**MINUTES
CITY OF LAKEWOOD
BOARD OF BUILDING STANDARDS/
ARCHITECTURAL BOARD OF REVIEW/SIGN REVIEW
MARCH 12, 2020 at 5:30 P.M.
LAKEWOOD CITY HALL
AUDITORIUM**

City of Lakewood
Architectural Board of Review
Approved as set forth in the minutes

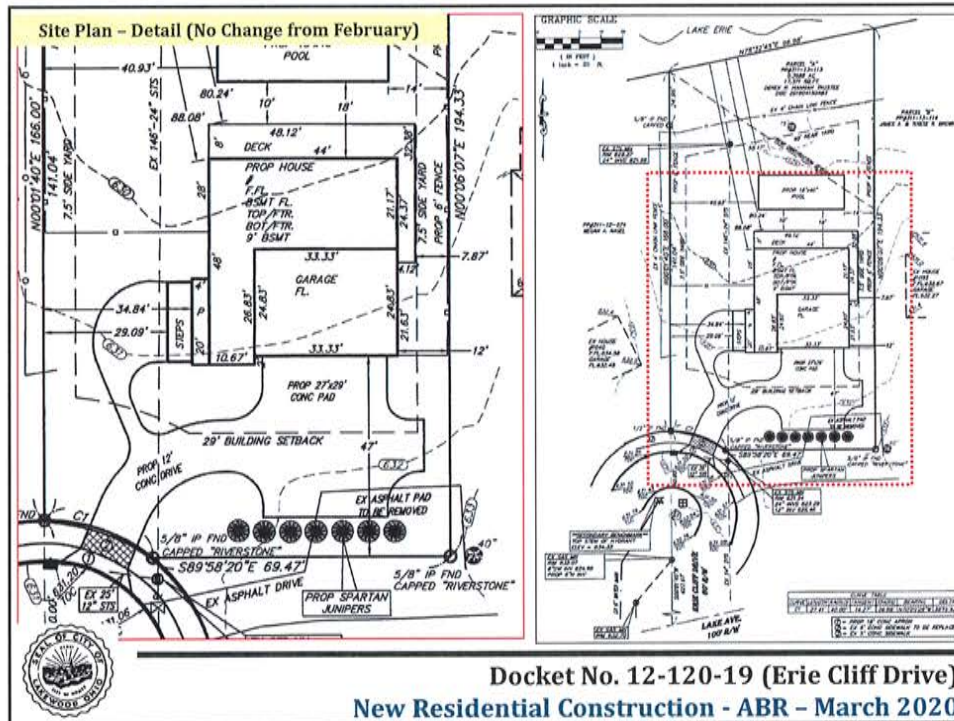
Post Pre-Review (5 March) Notes

- Consider extending front entry canopy along the west façade to break up massing and mimic a front porch.
- Confirm materials/colors – recommend panels on tower and siding on remainder of house, vertical siding below datum line established by extension of front-entry canopy along the western façade.
- Highlight proposed/modernized design elements in context of neighborhood/adjacent homes.
- Lighting plan – provide specifications on the desired fixtures and locations.
- Confirm fence location in relation to property lines.
- Provide other planned landscaping in addition to proposed trees already presented

**Docket No. 12-120-19 (Erie Cliff Drive)
New Residential Construction - ABR - March 2020**

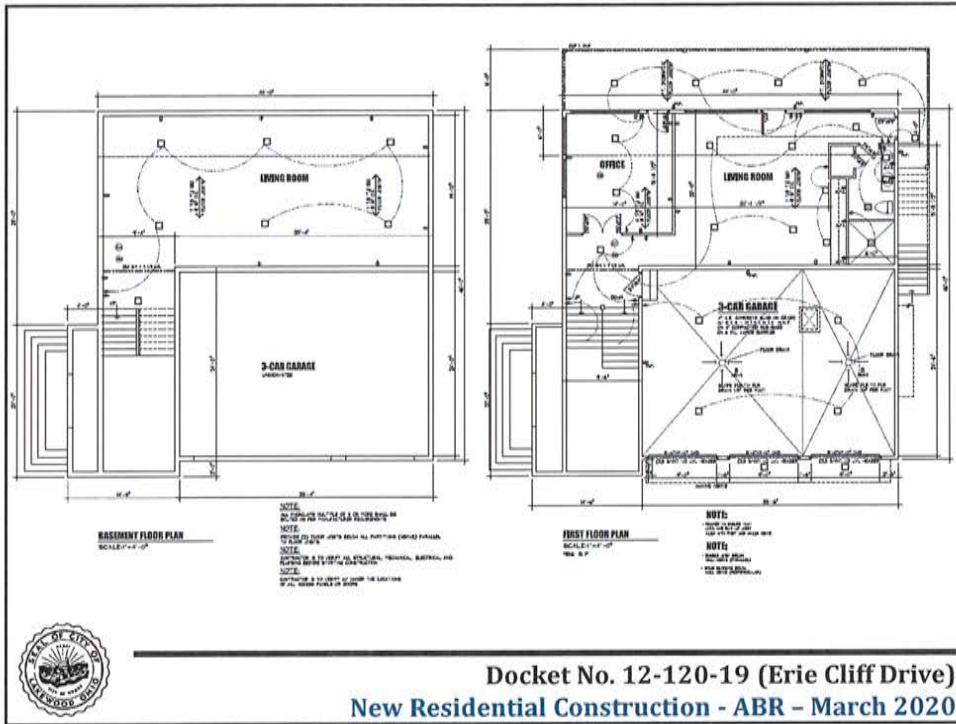
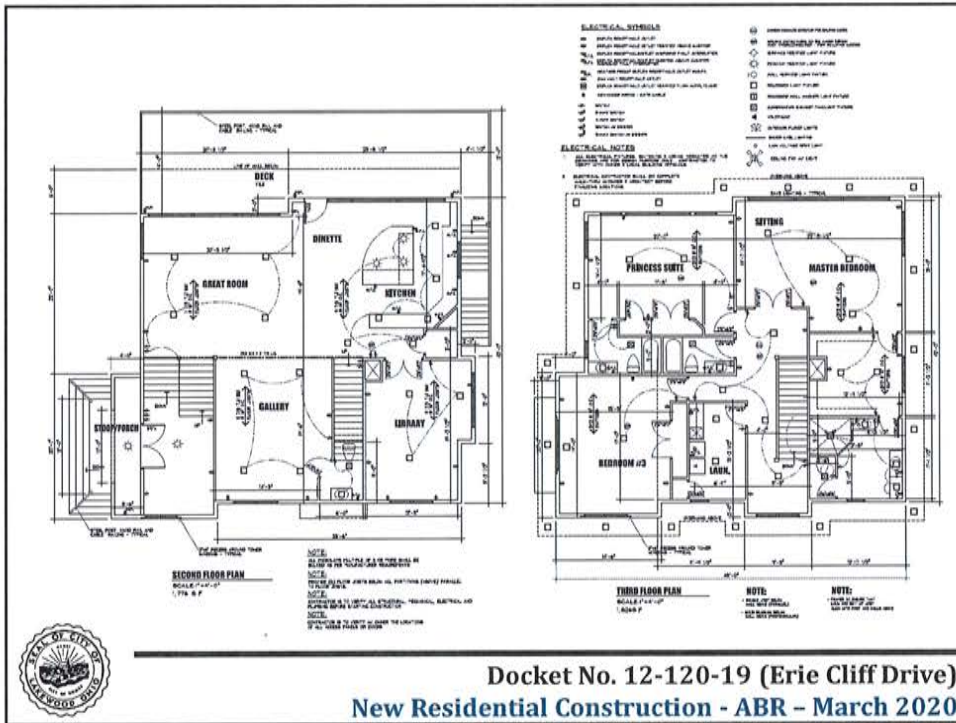
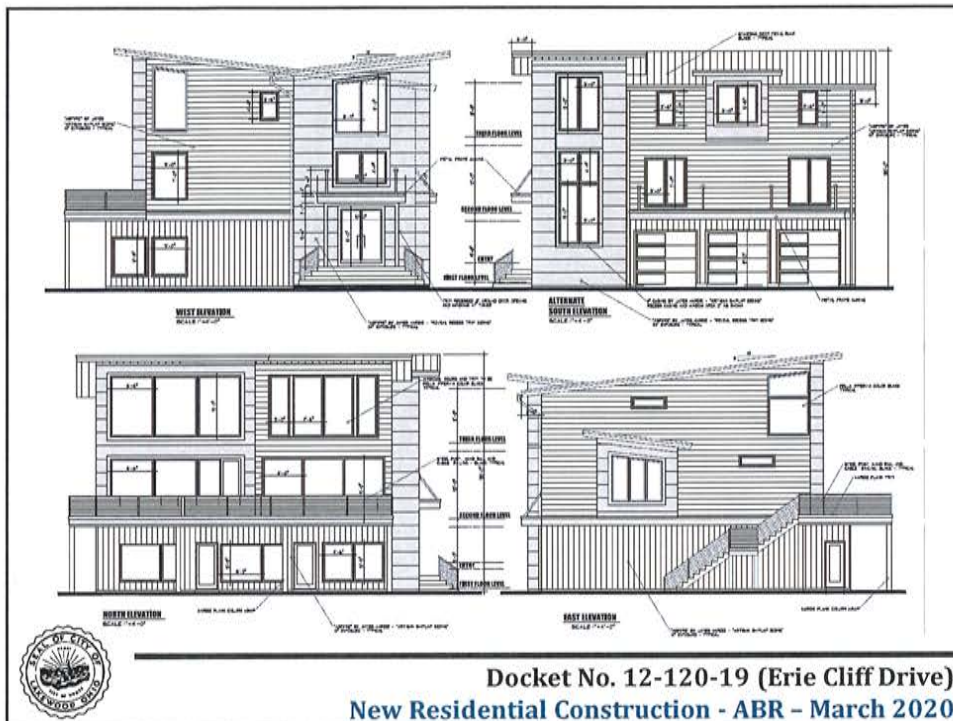
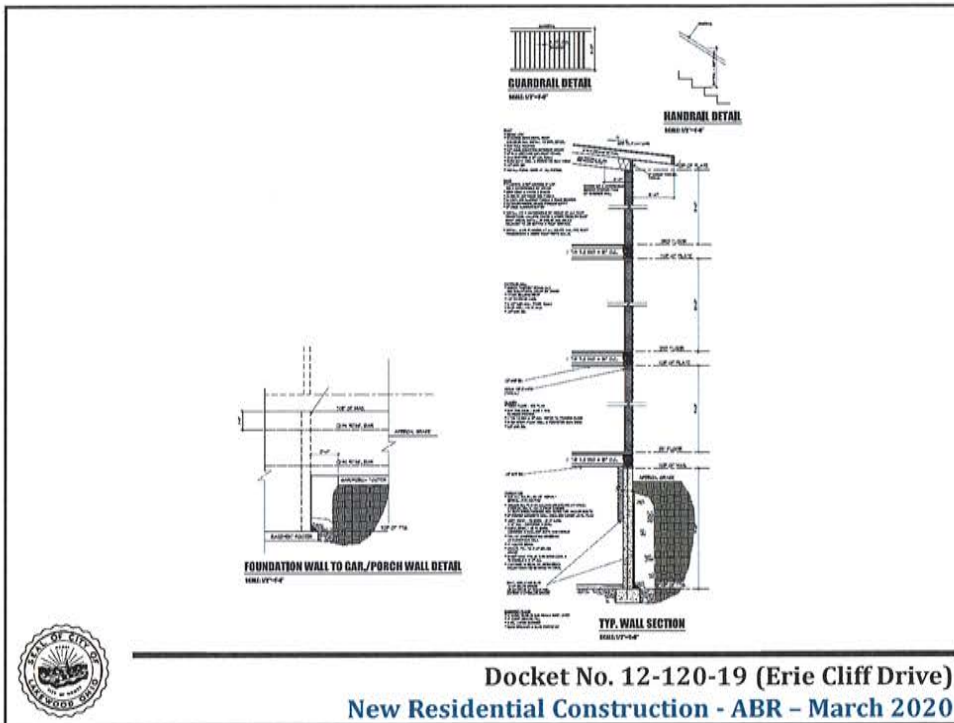
Staff provided an introduction of the project. Derek Hanna, applicant and property owner, was present to explain the request. Discussion continued about siding materials (wood tone and grey), clad windows (black), covered front stoop with wire railing versus a porch (photographs were submitted by the applicant for the evening's meeting were made part of record), location of the wrought-iron style fence (middle of the western wall and by the front of the house on the east side), garage doors colors (grey with black), alignment of the windows, current structure rendering blends better with the neighborhood, front street landscaping trees would create a visual barrier. Staff had no additional comments. Public comment was taken. Three e-mails from the public disclosing their concerns were read into record by staff (made part of record). Staff thanked everyone for their comments and hard work in seeking a balance for the project, despite site plan limitations and existing City easement; staff supported the proposal. The Board echoed staff comments. Discussion continued about for height/elevations, recessed light cans, full light front door (t be reviewed/approved administratively), front plantings would be six-foot arborvitae

Concern 2 - With a full 3 story front, this home is not harmonious with the street, and has a cold appearance due to no architectural detail and no front porch.

Concern 3 - It appears that the plan is to cut another apron off of the circle, which causes concern for rainwater management, as expressed at an earlier meeting. Is there a need to conduct a study to review the impact of this construction on lakefront erosion ?

Conditions for approval:

- Doors to be reviewed/approved administratively.
- Trees on the southern edge are six-foot arborvitae.
- Clad windows are black in color.
